| Project                      | <b>IEEE 802.16 Broadband Wireless Access Working Group</b> < <a href="http://ieee802.org/16">http://ieee802.org/16</a> >

Figure 1. Example of semi-static channel definition and DL access allocation to reduce overhead (The channels layout shown above is logical).

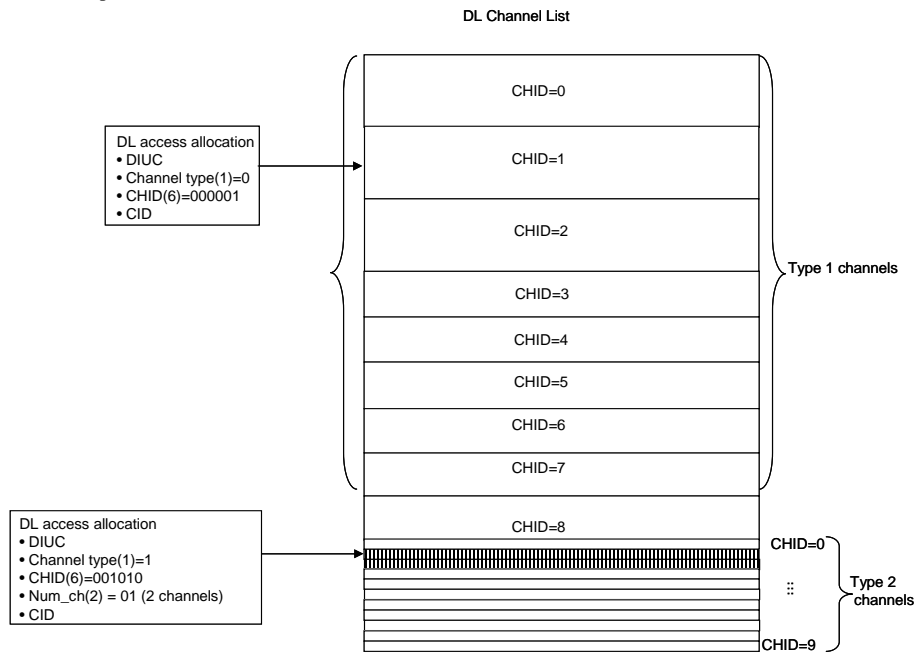
Figure 1 shows an example of the above scheme.

Using the above scheme, the total overhead involved in defining DL access regions is reduced from 560 bits to 140 bits (assume 20 Type 1 channels).

In fact, the overhead can be further reduced by omitting the CHID field in the DL access allocation. This is possible by setting the rule that each subsequent DL access allocation corresponds to the next increment of the CHID value of a particular channel type. In this way, the overhead involved in defining DL access regions can be further reduced to 20 bits (assume 20 channels).

Figure 3. Example of semi-static channel definition and DL access allocation for the case where there is irregular assignment that overlaps with region defined for the semi-static channel (The channels layout shown above is logical)

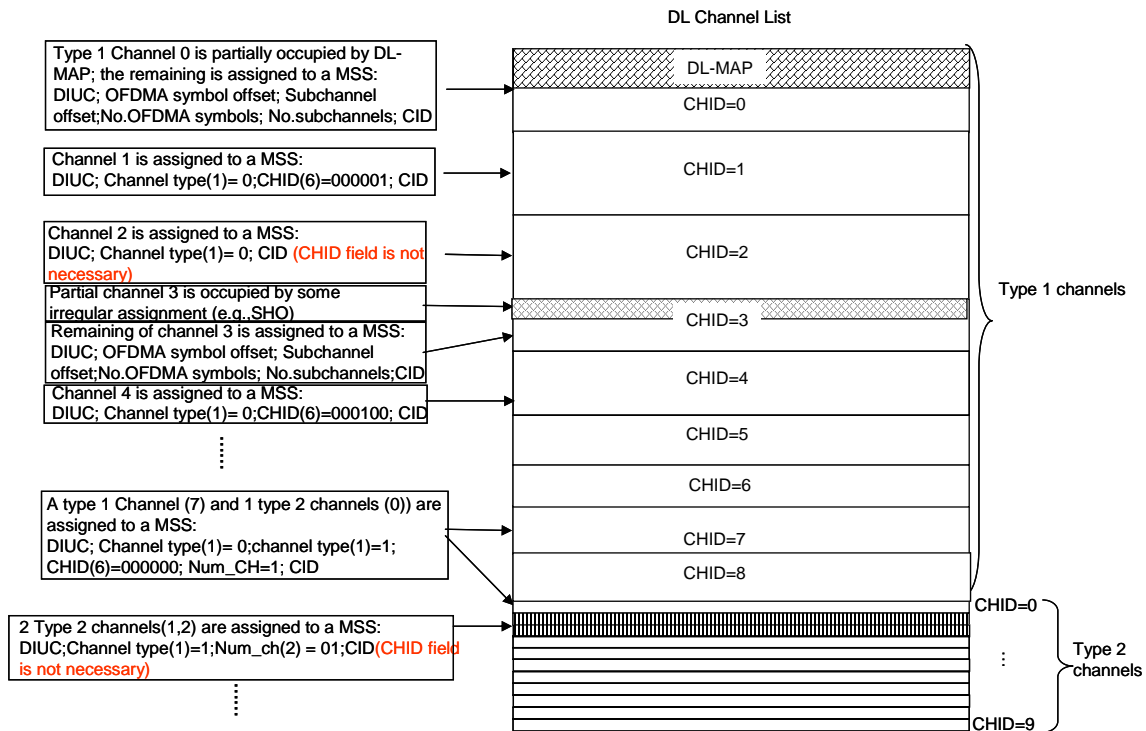
The case shown in Figure 2 above (i.e. CHID omission) may not always be possible under certain situation where the access region defined for certain semi-static channels is assigned to or overlapped with other 'irregular' region allocation, e.g. DL/UL-MAP, SHO zone. Under such situation, the CHID needs to be included for the next semi-static channel assignment following the 'irregular' region. For subsequent semi-static channel assignments, CHID can again be omitted. This is illustrated in Figure 3, which includes scenarios where DL-MAP occupies partially the region defined for Type 1 channel #0 and SHO region occupies partially the region defined for Type 1 channel #3. For the above 2 scenarios, CHID is required for the next semi-static channel assigned following the 'irregular' region.
